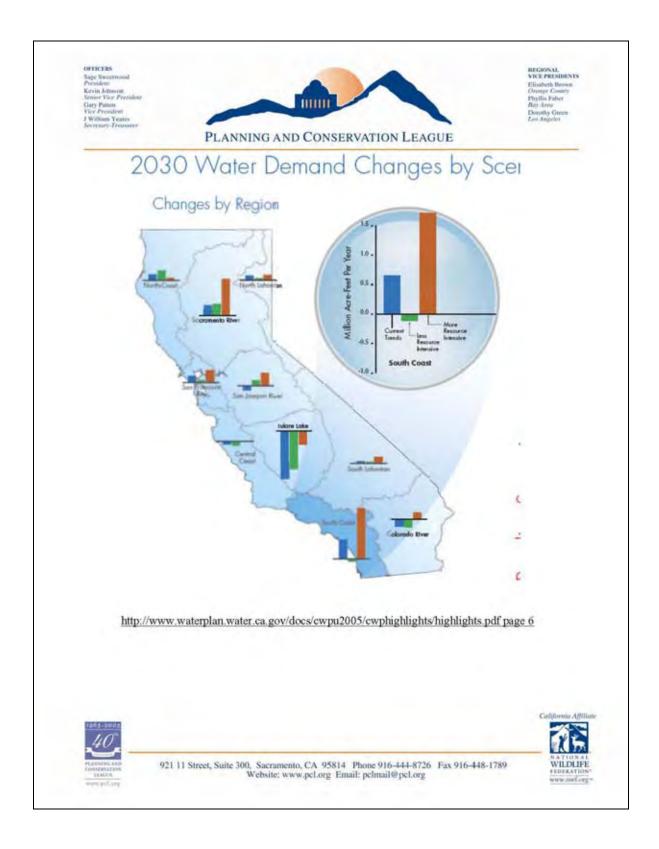
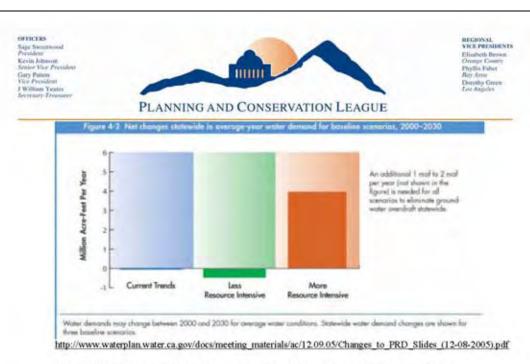
The figures included below were taken from the California Water Plan Update documents. The first figure presents data indicating that the net South of Delta demands could decrease in both the Current Trends Continued and the Less Resources Insensitive scenarios. The second figure reports the estimated net statewide demand changes under all three scenarios. The second figure indicates that statewide, demands will decrease in both the Current Trends Continued and the Less Resources Intensive scenarios.²

These studies indicate that, despite the DEIS/R assertion that there are unmet needs south of the Delta, increased exports from the Bay Delta Estuary are unnecessary. In fact, the water demand data from DWR's Water Plan Update 2005 and the Pacific Institute report demonstrates that exports from the Bay Delta Estuary could actually decrease to match decreased demands.

Yet the DEIS/R does not even acknowledge these studies. It is inappropriate and misleading that DWR based its analysis of project need on outdated assumptions about South-of-Delta demand, yet omitted from this DEIS/R its most recent information on water demand trends.

Please see Master Response L, Relationship between the South Delta Improvements Program and the California Water Plan Update 2005.

Figure 8. Exceedance probability plot of SWP Annual Deliveries under climate change scenarios PCM B1-A1 and HadCM3 B1-A1 for 2070-2099

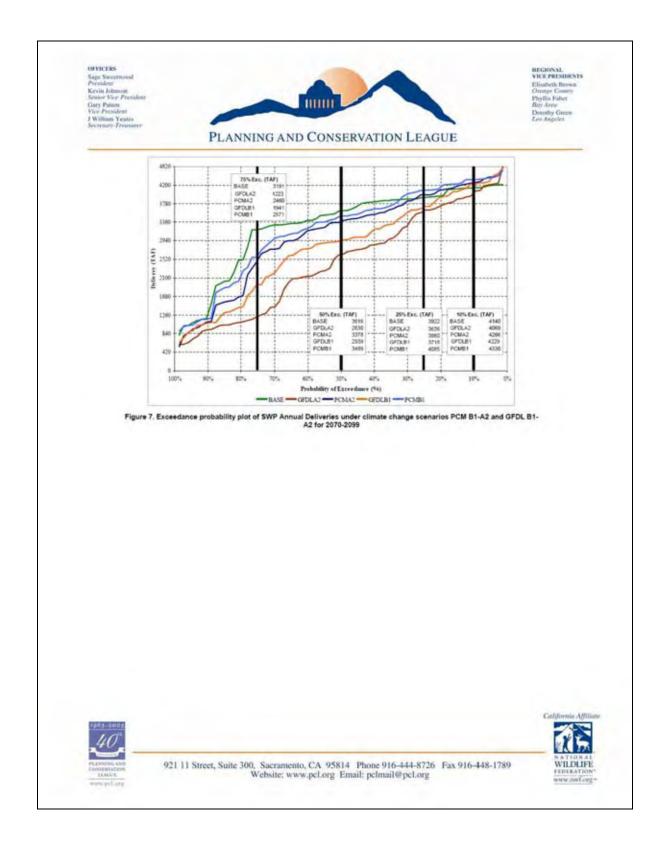
Since the release of the Draft Reliability Report 2002, a large amount of analysis on potential climate change impacts on water management in California has been published. Estimates of the deliveries from the SWP under climate change conditions have been modeled and analyzed. The California Energy Commission recently completed such an analysis in their report, "Predictions of Climate Change Impacts on California Water Resources Using CalSim-II: A Technical Note" (CEC report); Katherine Hayhoe et al., Emissions Pathways, Climate Change, and Impacts on California (2004) at http://www.fypower.org/pdf/NatAcadSciClimateChange.pdf.

The CEC report concluded that modeling, "results show great negative impacts on California hydrology and water resources associated with most of climate change scenarios analyzed (only one scenario PCM run under B1 emission scenarios show just mild negative impacts)." (page 4)

Please see Master Response F, Relationship between the South Delta Improvements Program and Climate Change Effects.
